## Kroger Office Expansion JSP13-65

Consideration of the request of The Kroger Company of Michigan for Preliminary Site Plan and Stormwater Management Plan approval. The subject property is located in Section 24, at 40393 Grand River Avenue, west of Seeley Road in the I-1, Light Industrial District. The subject property is 1.63 acres and the applicant is proposing to add a 2,019 square foot addition on the north side of the existing building.

## PLAN REVIEW CENTER REPORT

Kroger Office Expansion  
JSP13-0065

Sheet no.  
**1 OF 3**

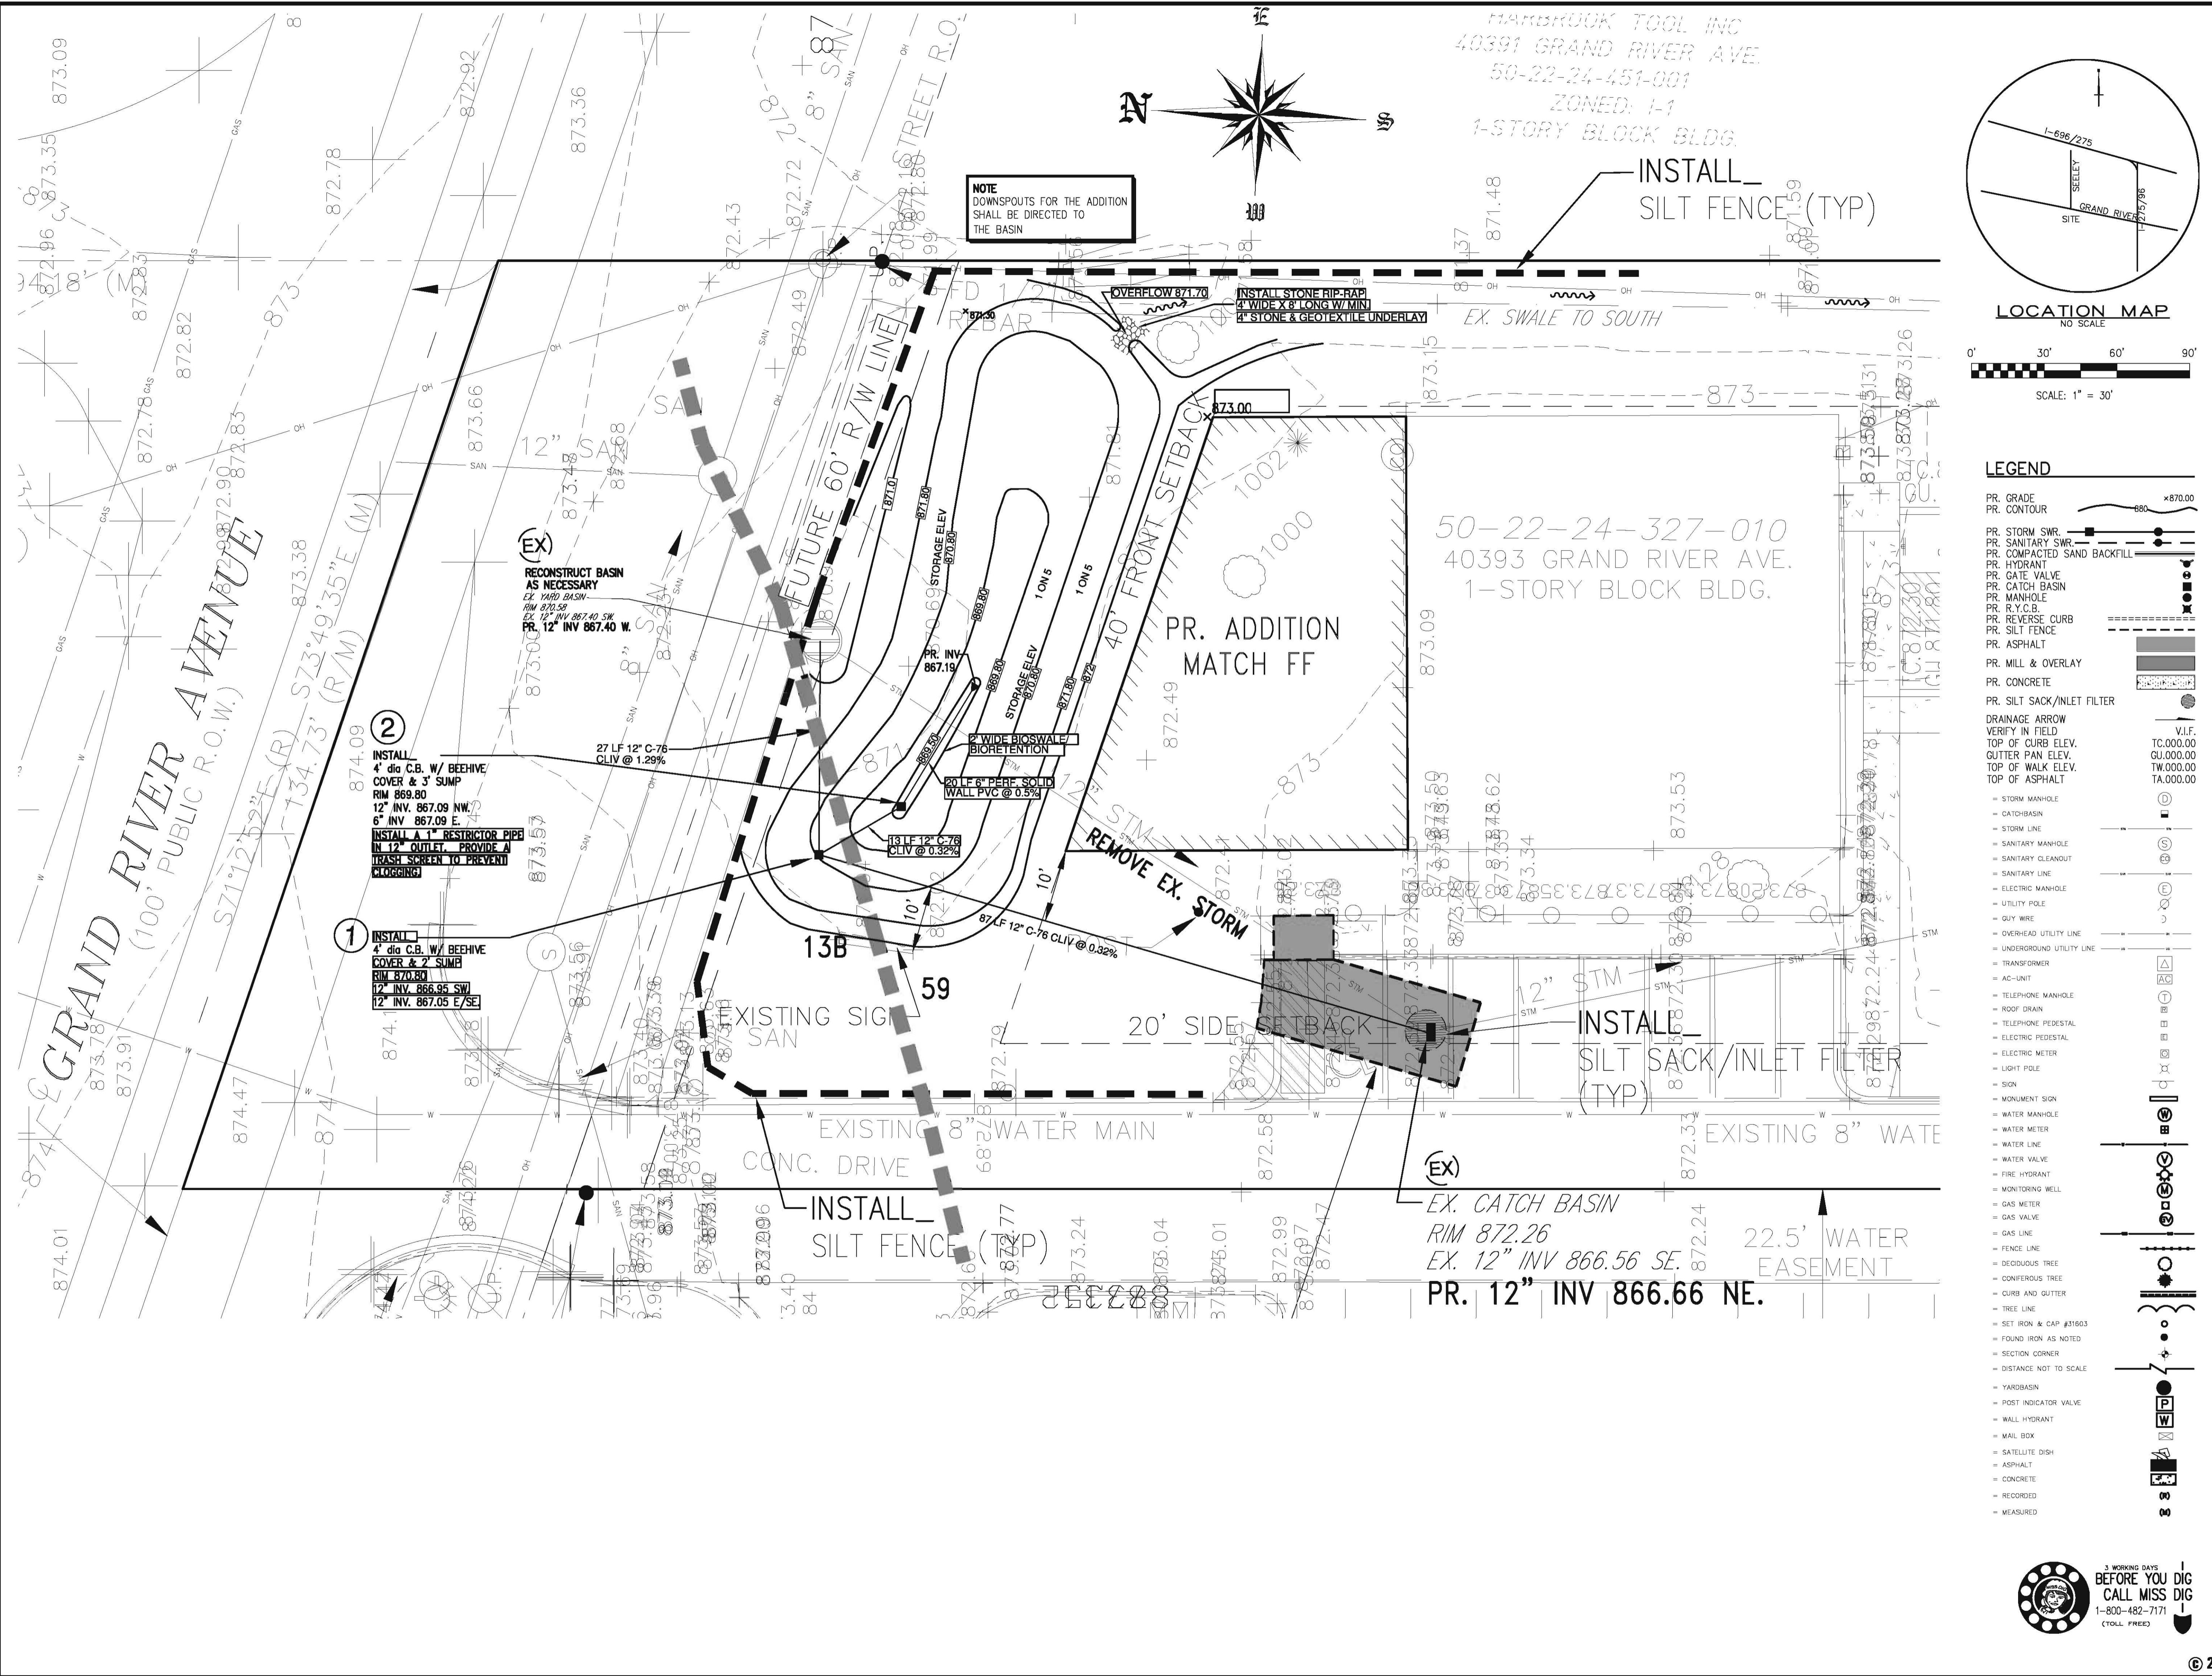
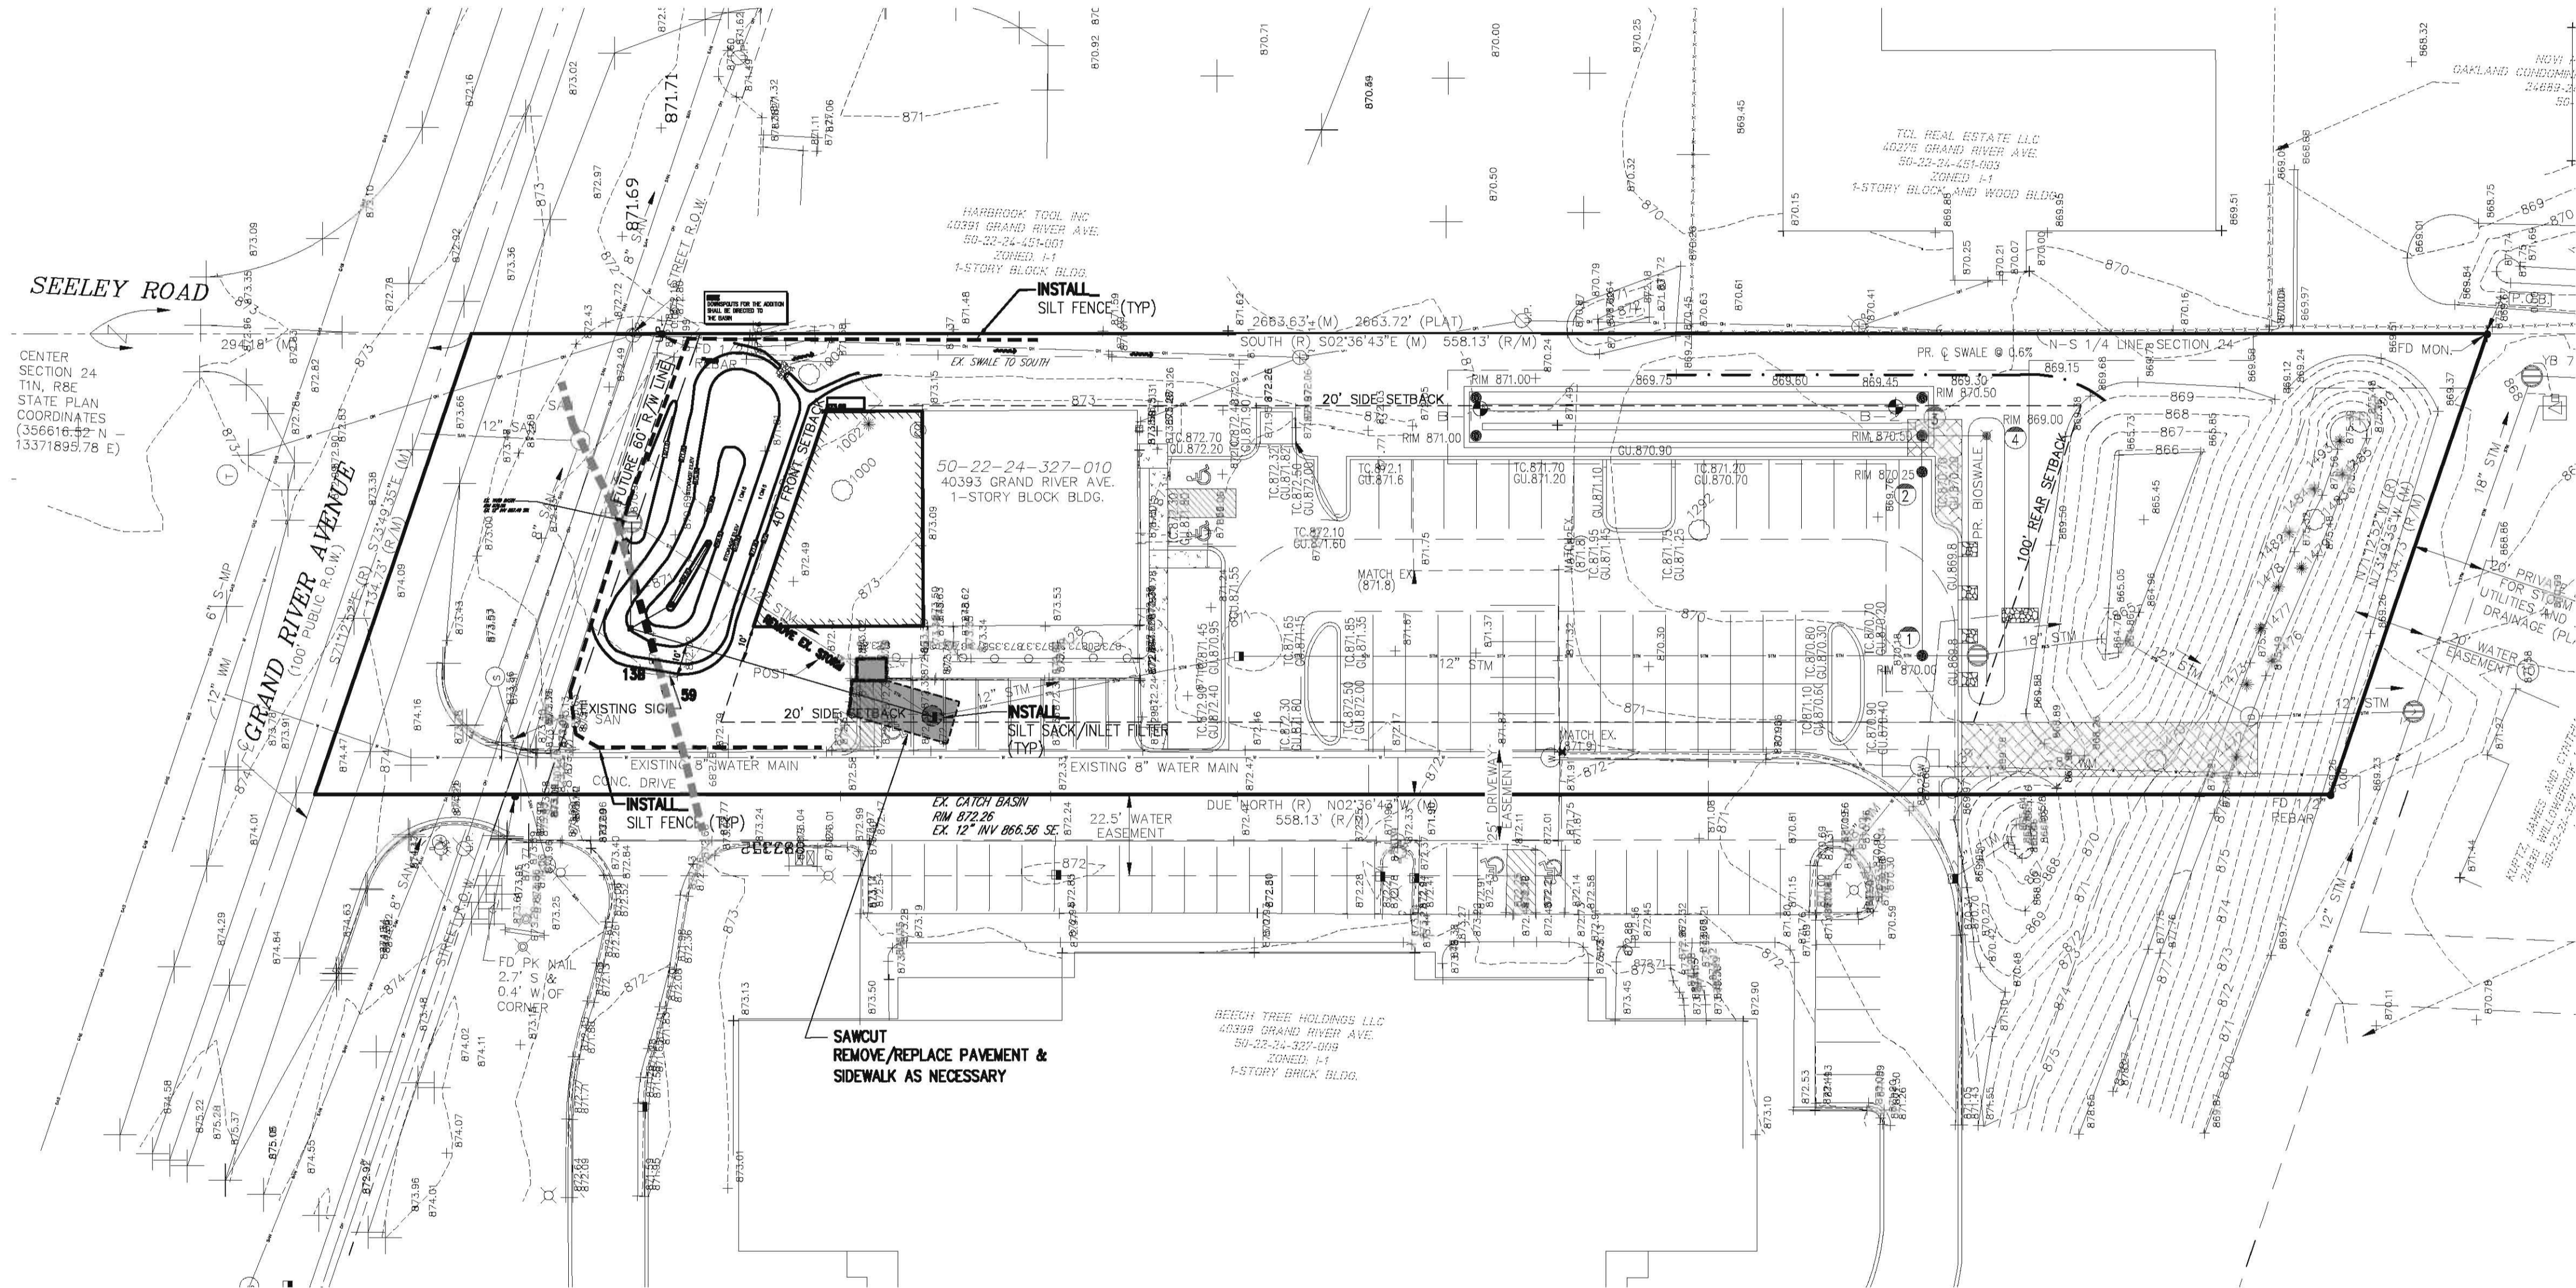
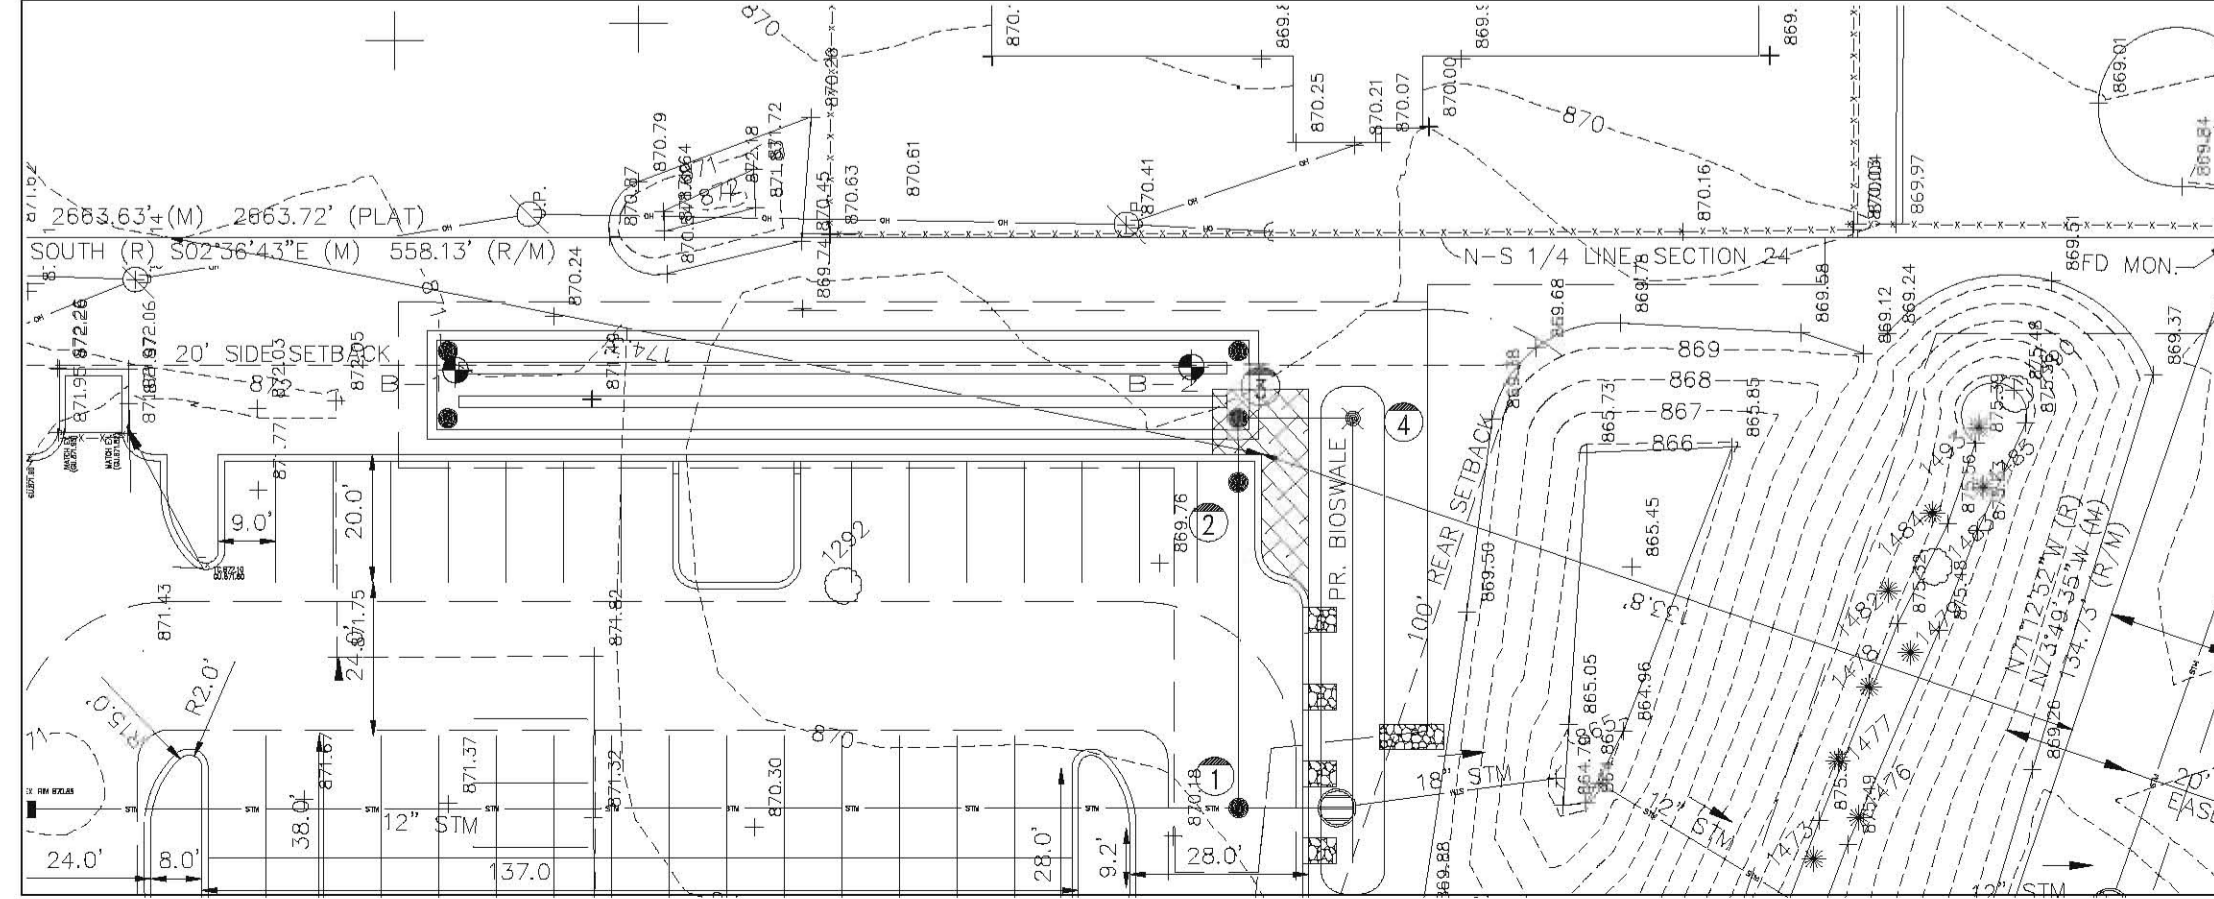
1. Provide the City's standard detail sheet for storm sewer (1 Sheet-6/15/98) at the time of the Stamping Set submittal.
2. Remove "City of Novi inspecting engineers shall verify the bearing capacity of native soils to verify an adequate bedding depth is provided" from plan sheet 1 of 3.
